Three Mile Island Nuclear Station Unit No. 1
Docket Number 50-289

Errata Sheet to responses to questions raised in Enclosure 2
of the NRC's 2-18-76 letter to TMI-1 concerning Appendix I

RESPONSES TO QUESTIONS RAISED IN ENCLOSURE 2

CONCERNING APPENDIX I

FIGURE 8-8

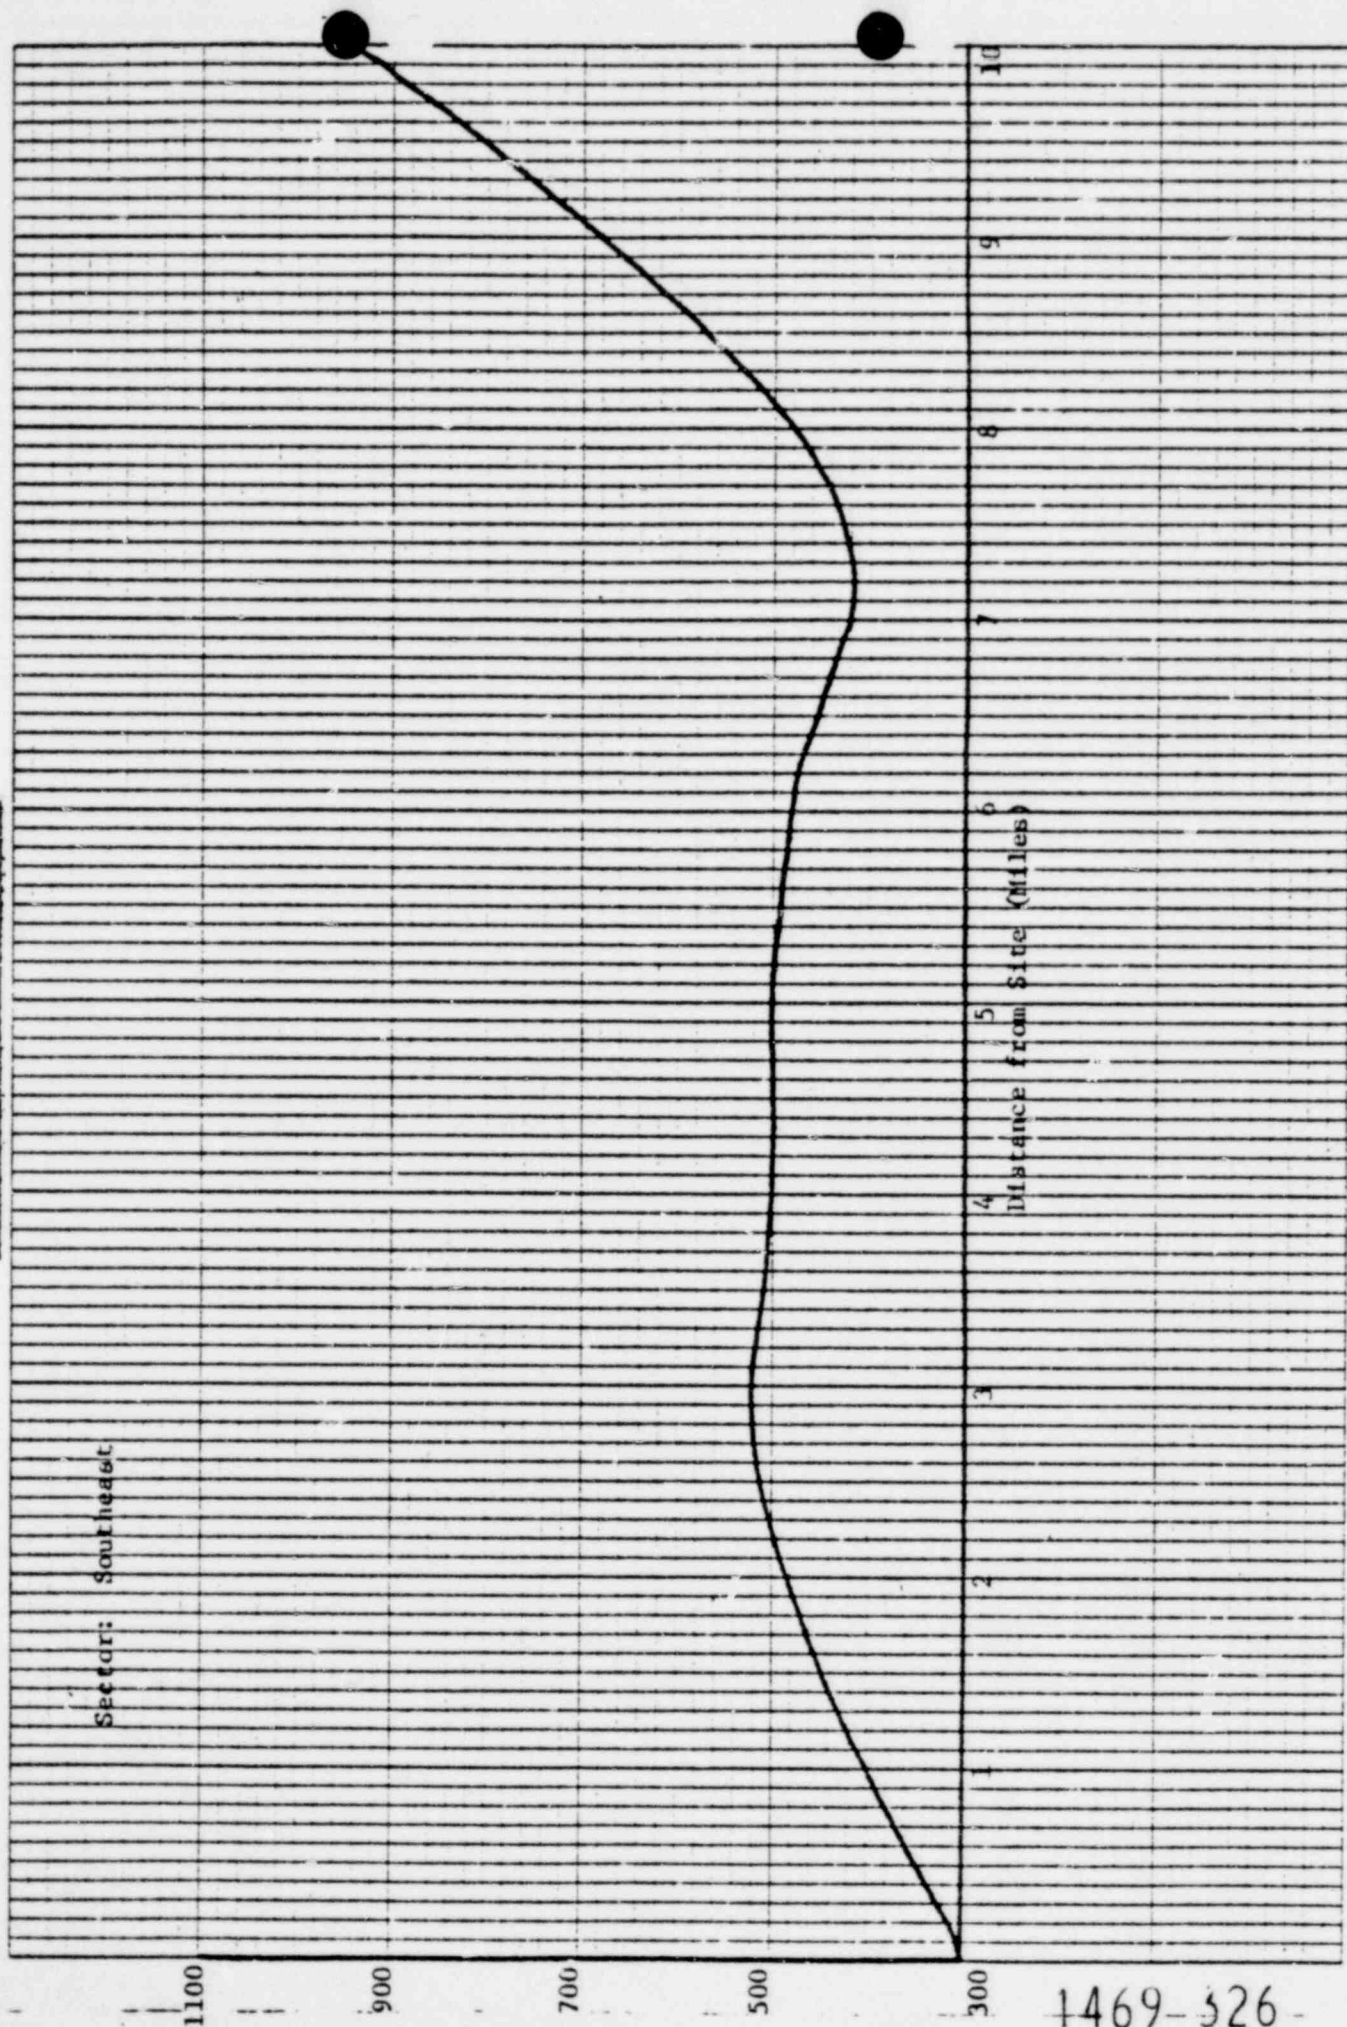
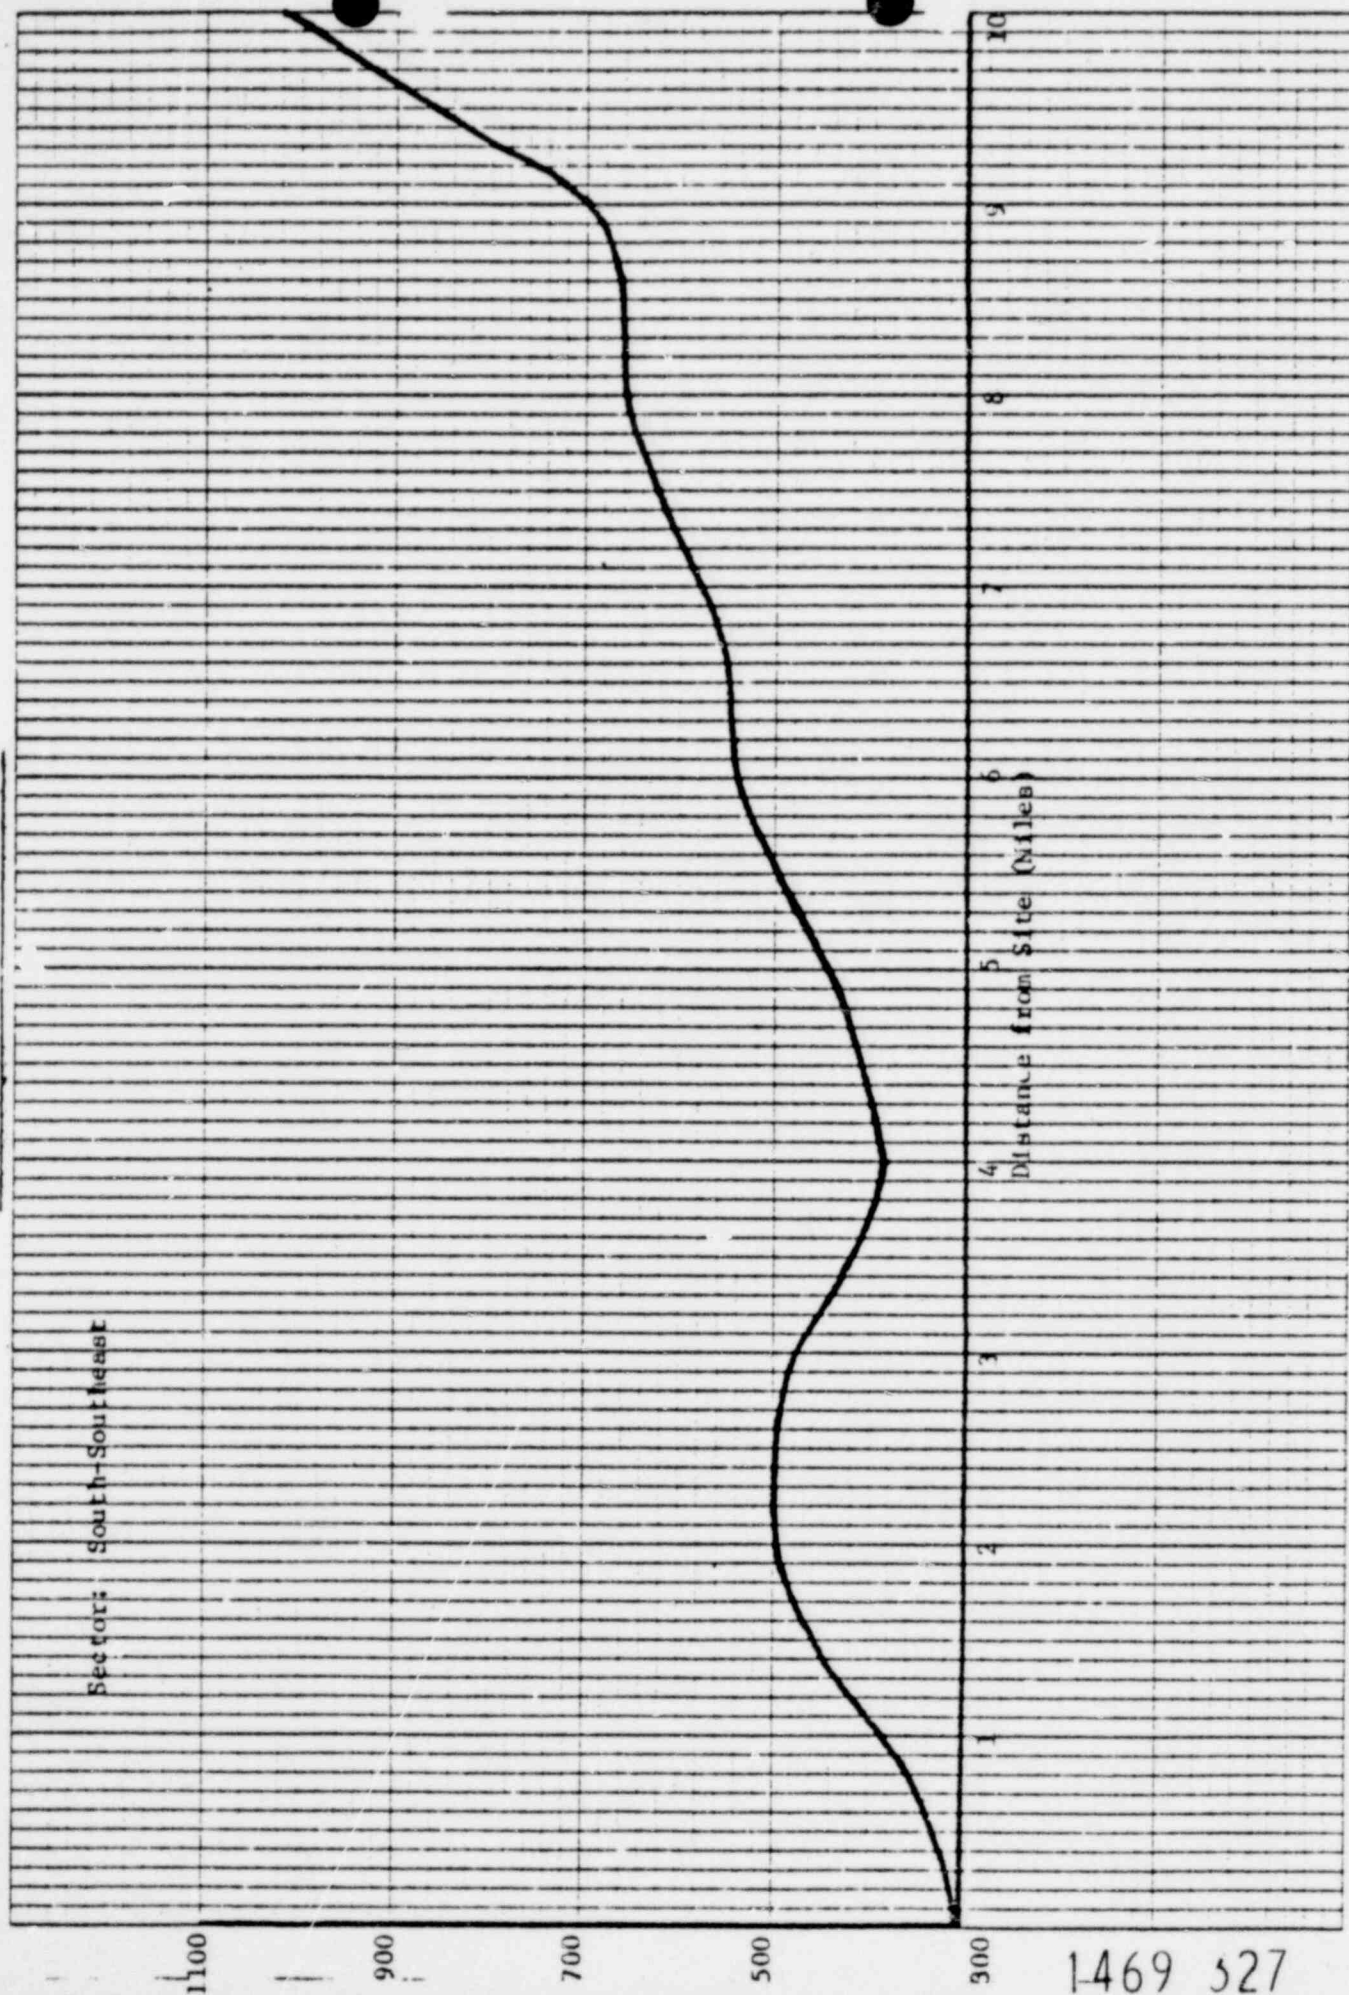
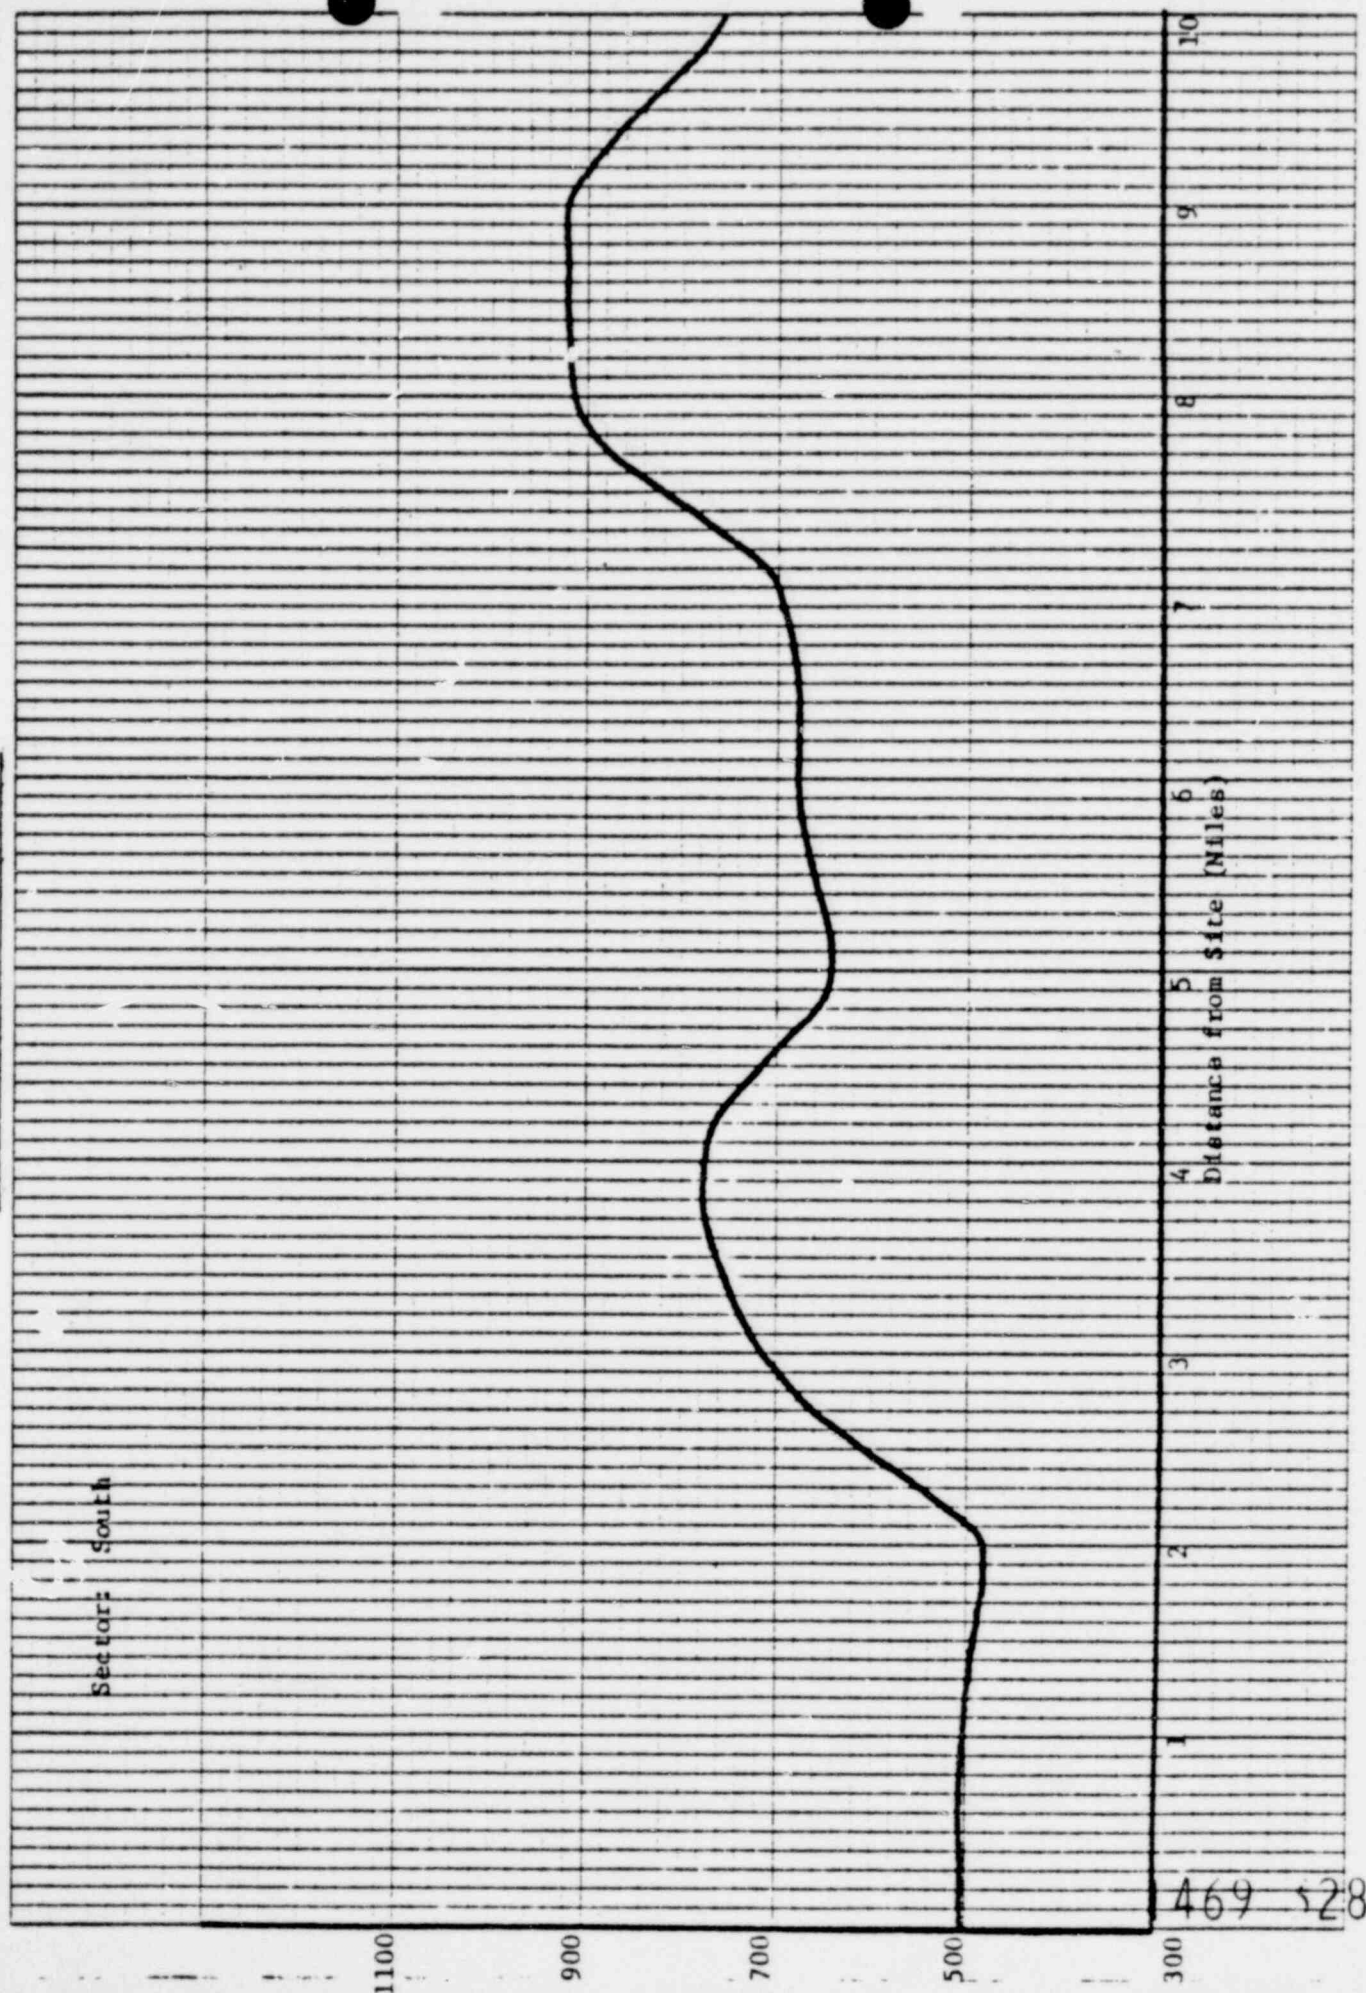
Provide a map showing the detailed topographical features (as modified by the plant) on a large scale, within a 10-mile radius of the plant and a plot of the maximum topographic elevation versus distance from the center of the plant in each of the sixteen 22-1/2 degree cardinal compass point sectors (centered on true north), radiating from the center of the plant, to a distance of 10 miles.

RESPONSE

See attached Table 8-1 and Figures 8-1 through 8-16.
